# Casino Site Plan Review

Report to: Mayor Michael A. Nutter, City of Philadelphia

- This report was prepared at the request of Philadelphia Mayor Michael A. Nutter. It is the product of a casino site plan review workshop convened by PennPraxis from July 29 through July 31, 2008.

**Figure 2: Dual Left Turn Lanes as an Approach to Traffic Mitigation**

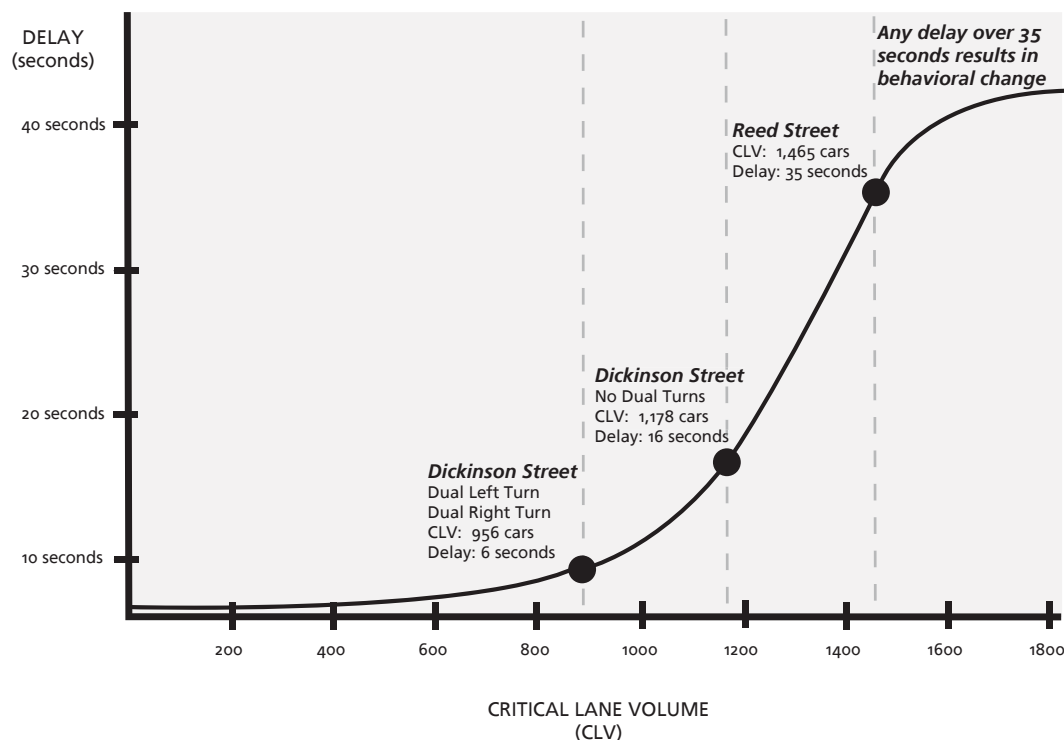
beyond what is typically acceptable in urbanized areas. For instance, the proposed second left-turn lane at Dickinson Street (the primary entrance to Foxwoods) results in a Level-of-Service (LOS) ‘A’ for the 2018 Saturday peak. This is considered an excessively “free-flow” condition in urban areas. Figure 2 demonstrates—based on a “Critical Lane Volume” methodology—that the total average time savings that would result from this second left-turn lane would be approximately 10 seconds per vehicle. Moreover, this level of time savings is relevant only during the absolute peak hour (early Saturday afternoon) which would occur just once per week (in contrast to the typical weekday morning/evening peaks which occur five times per week). The travel time savings during other periods would be much less significant if at all discernable.

Although this evaluation supports the strategic addition of single left-turn lanes at critical locations (which account for the slight “dip” toward auto-orientation evident in Figure 1), dual-left-turn lanes are not recommended due to their marginal impact on traffic flow in comparison with their overall detrimental effect on the civic vision. Projected impacts on traffic congestion of eliminating these dual-turn-lanes would be moderated by proposed transit improvements in conjunction with adjustments of the travel behavior of future visitors (see Figure 2) , including:

- **Elimination of all dual-left-turn lanes from the transportation mitigation program.** Dual-left-turn lanes are the most damaging of all potential traffic measures with respect to the civic vision. Based on independent analysis, it has been determined that these measures offer very little real benefit

**Figure 3: Foxwoods Site Access, Current and Workshop Proposed**

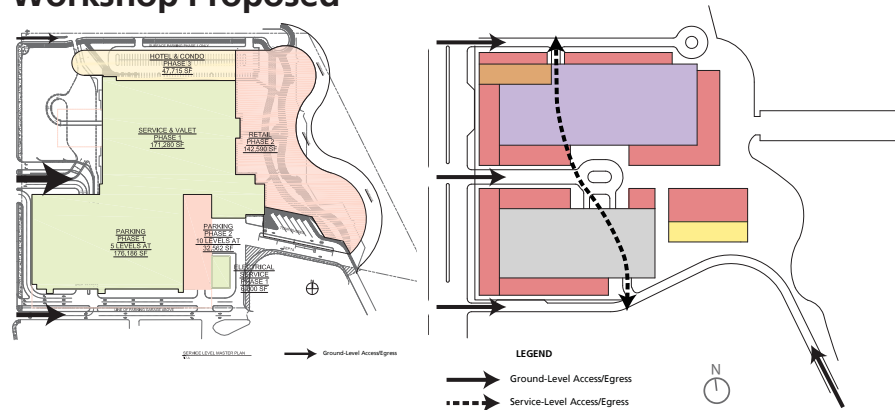
- **Reorientation/reconnection of internal street network to allow maximum flexibility for site access/egress.** Any large urban development can benefit from multiple access/egress points to/from its main parking supply, which allows the “even-ing out” of the distribution of turn movements to/from the main thoroughfare (in this case Delaware Avenue/Columbus Boulevard). This avoids over-concentration of traffic at just one or two primary access points, which is a condition that typically leads to mitigation measures such as dual-left-turn lanes. Given the proposed modified site plans, Figures 3 and 4 illustrate the implications of this improved interconnectivity on the distribution of site access. The thickness of the arrows depicts the relative distribution of traffic entering from Delaware Avenue.

**Current design, Foxwoods Casino**

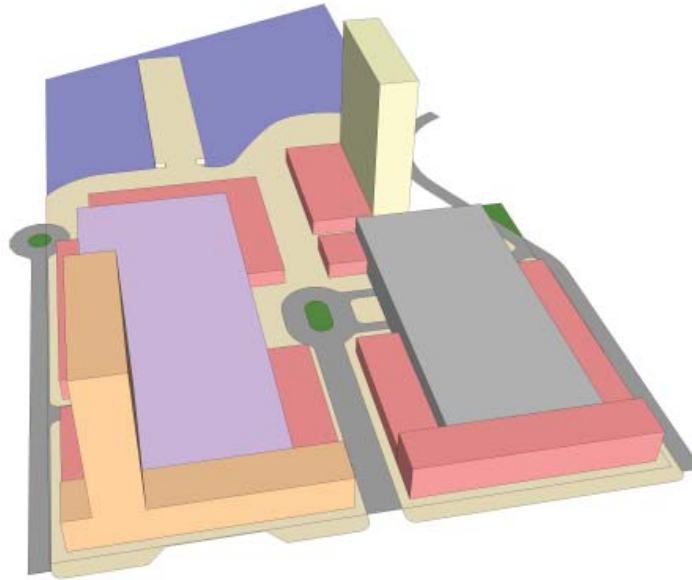
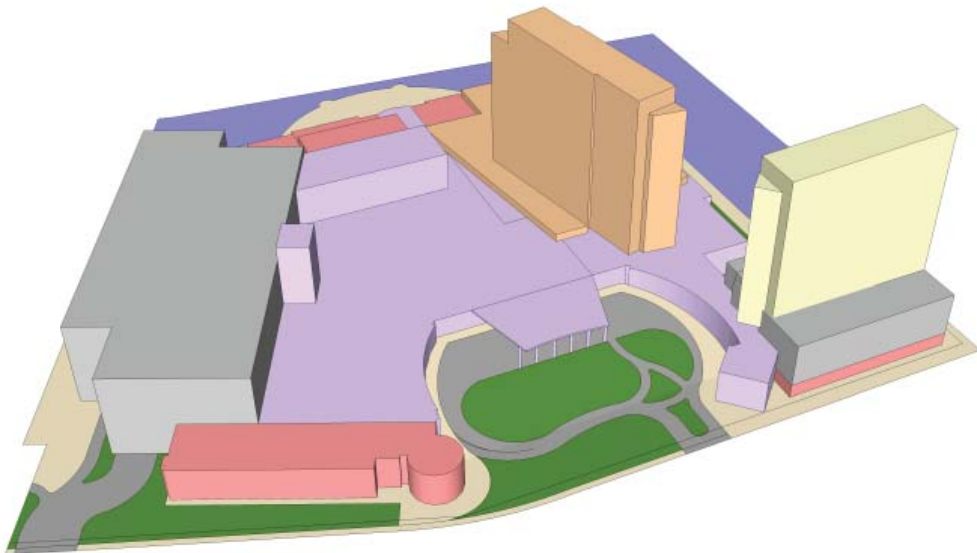
The casino site design workshop explored ways that the casinos might contribute to the waterfront community and produced recommendations for specific design components for each site. The review-team proposed substantial modifications which could contribute to the civic vision, and demonstrated important trade-offs in design and program which should inform decision-making at the city and state level, including bringing streets and public access ways through the site; creating the 100-foot riparian buffer; dispersing building program across the site; wrapping the parking and casino floor with active uses; and reducing the size of the parking structure. However, the schematic site plans produced during the workshop demonstrate the limitations of this type of building on these sites within the framework of the civic vision. In particular, the large casino floor plate (similar to the Gallery at Market East and the US Mint at 4<sup>th</sup> and Arch Streets) and the dominant garage structures (equal to ¼ of all of the parking at Philadelphia International Airport on one site) create superblock-scaled designs that are difficult to urbanize and do not contribute to the civic vision.

- Invoke the 500-foot block scale of the civic vision (which is drawn from the traditional Philadelphia block-size) by building streets that provide perpendicular riverfront access and frame more urban scale development parcels.

- Design buildings that are scaled to fit this new urban fabric.
- Modify the valet parking and porte-cochere area within the current casino site plans by pulling these functions off Columbus Boulevard/Delaware Avenue and making a through-block connection that preserves a grand entrance while enhancing the character of the urban boulevard. This through-street becomes part of a street network that increases overall site, neighborhood and riverfront connectivity.

- Create an on-site street network (above and below grade) that helps disperse auto traffic as well as incorporates “complete streets” that provide parallel and perpendicular connectivity for pedestrians, bicyclists, and autos.

### Current design, Foxwoods Casino

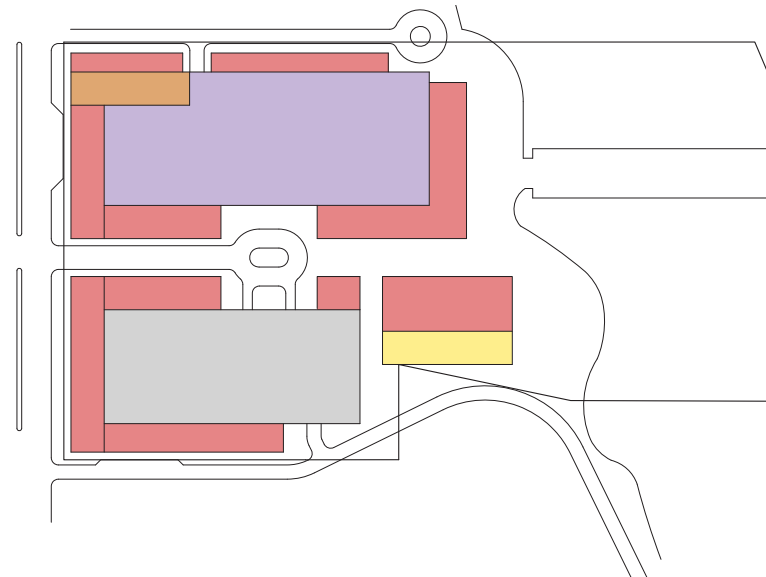
This workshop concluded that many modifications to the two 5000-slot machine casino parlors with their respective 4556- and 4011-car garages in Phase I could be made to the site designs that would enable them to contribute to the civic vision. These site plans show modifications that demonstrate how the casinos could be classified as partially contributing to the civic vision. However, the group concluded that the two casino projects cannot fully contribute to the civic vision, due to the scale of the projects and the impact of their parking structures on the urban landscape.

# Comparative Analysis Matrix

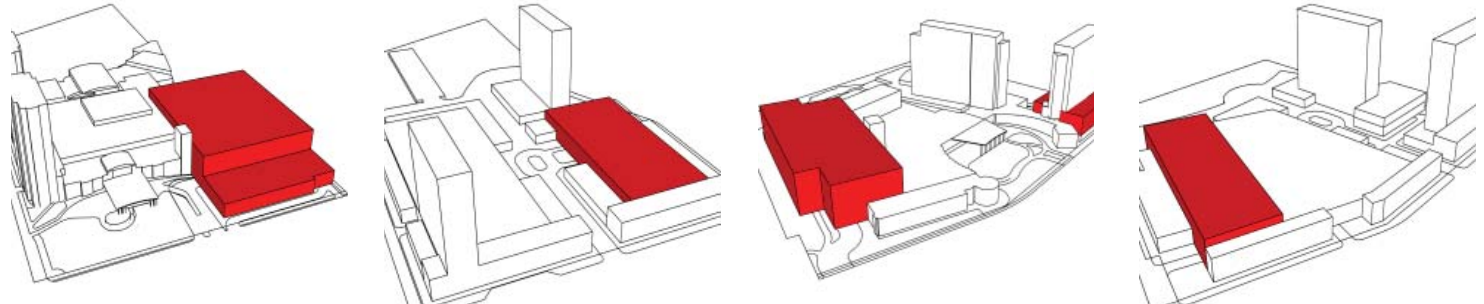
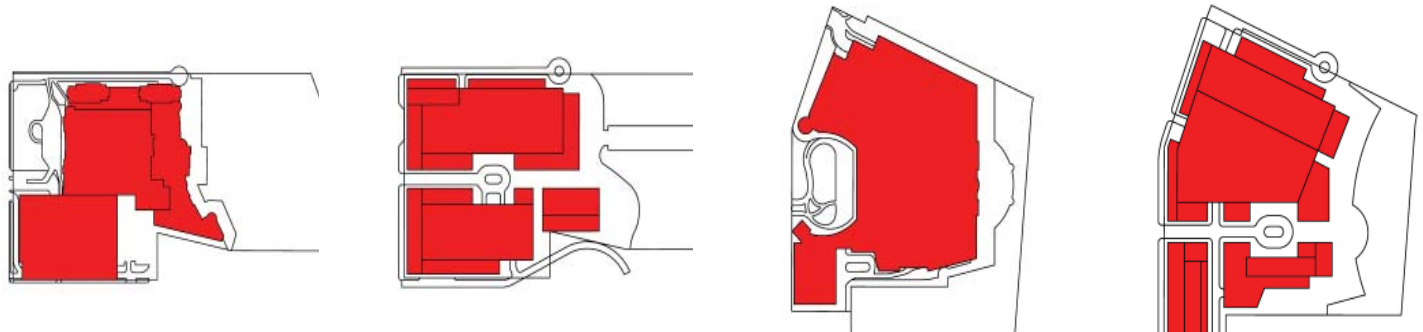
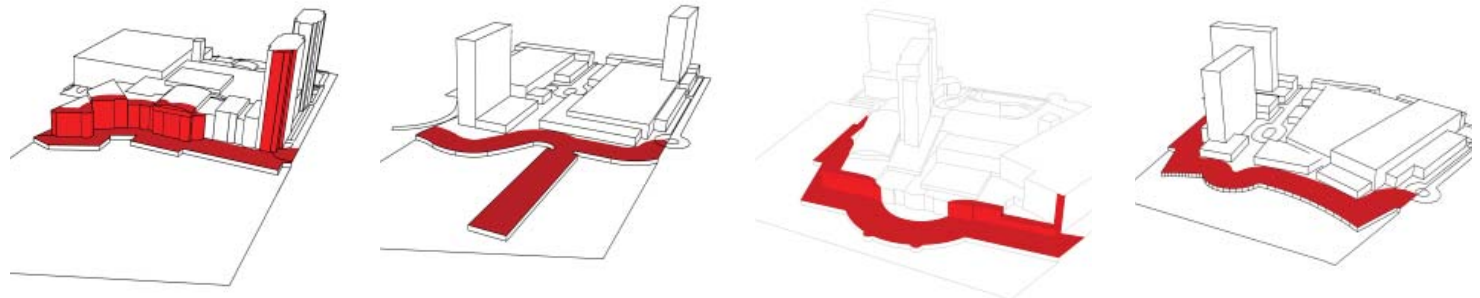
**Current:** The casinos do not provide street access every 500' and allow for building footprints which cover most of their sites. The SugarHouse site plan is equal to the size of the current Pennsylvania Convention Center.
